Product change notification (PCN)

Title / short description	PP-H 2,5 - Additional tool & change of the marking area
Affected article category	Terminal blocks
Change category	Material, Form and appearance
Change number	PBE240130-00
Reason for PCN/PDN Revision

**PCN Attachment
PBE240130
PP-H 2,5 - Additional
tool & change of the
marking area**

PP-H 2,5/1-L and similar old

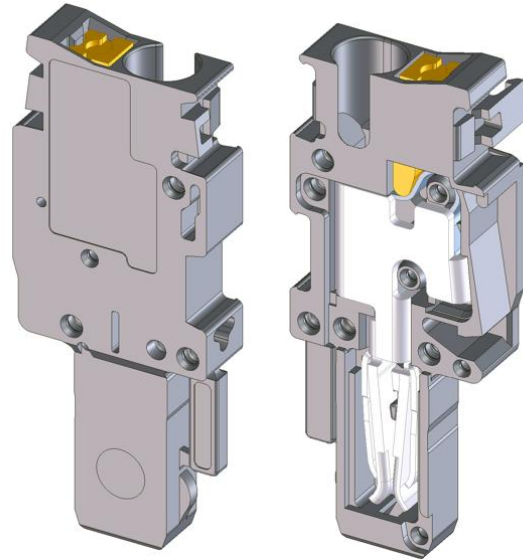
In order to meet the increased market demand for the PP-H 2.5 COMBI plug, new tools are being built for the products. This also involves making sensible changes to the product that improve functionality and/or production capability. In this case, the marking area is slightly changed and 2 visible contour changes will be implemented. The changes have no influence on the functionality, on the technical specification and the articles are backward compatible and can be combined with former versions.
